**CITY OF ROCKVILLE PLANNING DIVISION
STAFF REPORT**

SUBJECT: Use Permit Applications
USE2003-00671, 00672,
00673, 00674

- The applicant requests approval of four Use Permits that together comprise the buildings for the Rockville Town Square project. This is a mixed-use project including retail, multi-family residential, new streets, and a public plaza.

Blocks 1&2 Façade –
North Washington St.
(Preliminary)

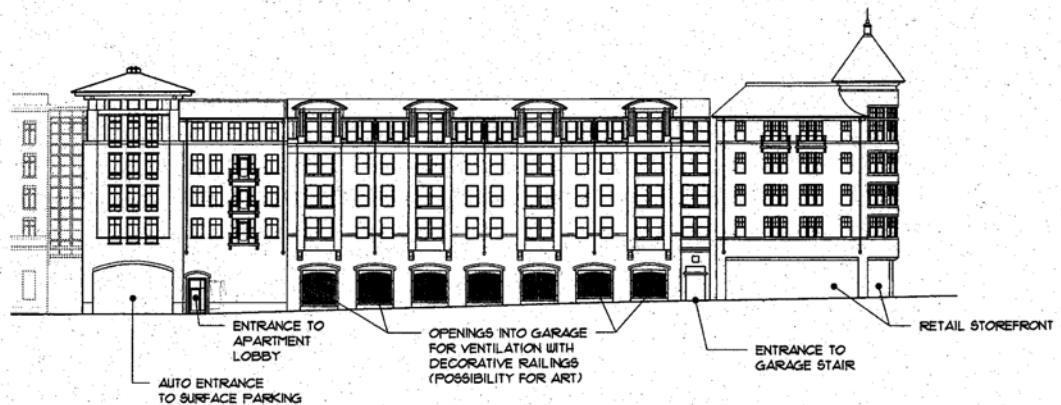
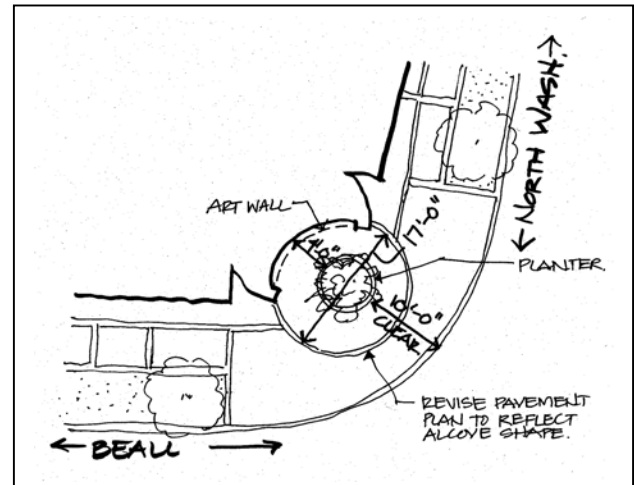
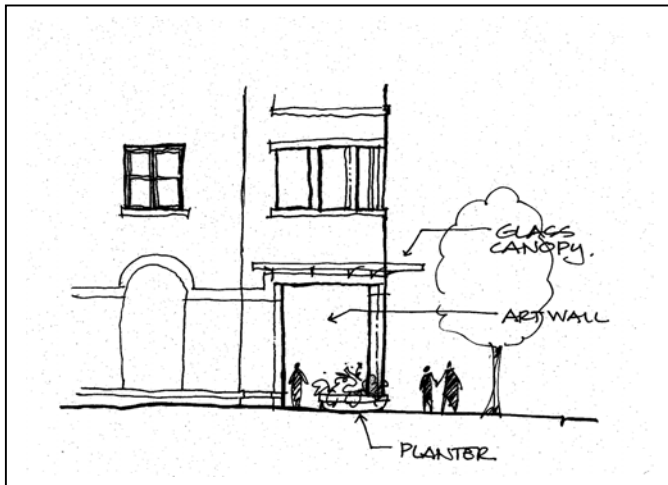
The facades on North Washington Street and Beall Avenue provide an opportunity for special treatment. At the street level, the façade needs to screen the surface parking lot on the south side, and serve as a wall for the grocery store on the north side. Because of the internal design of the grocery store, there can be no windows into the interior from the street. As a consequence, the design of the façade south of the driveway provides for arched openings that will be filled with a decorative grillework. This provides an opportunity for artistic treatment, within the needs for maintaining sufficient openness for air circulation in the garage.

North of the driveway, additional niches will provide space for additional artworks, most likely in the form of mosaics or murals. At the corner of North Washington and Beall Avenue, the corner of the building at the street level is proposed to be scalloped back into the building,

leaving the corner tower with a canopy to provide shelter and also another opportunity for art on the back wall. This can be integrated with an adjacent proposed bus shelter that will be constructed on the northwest side of the building and includes display window/community bulletin board.
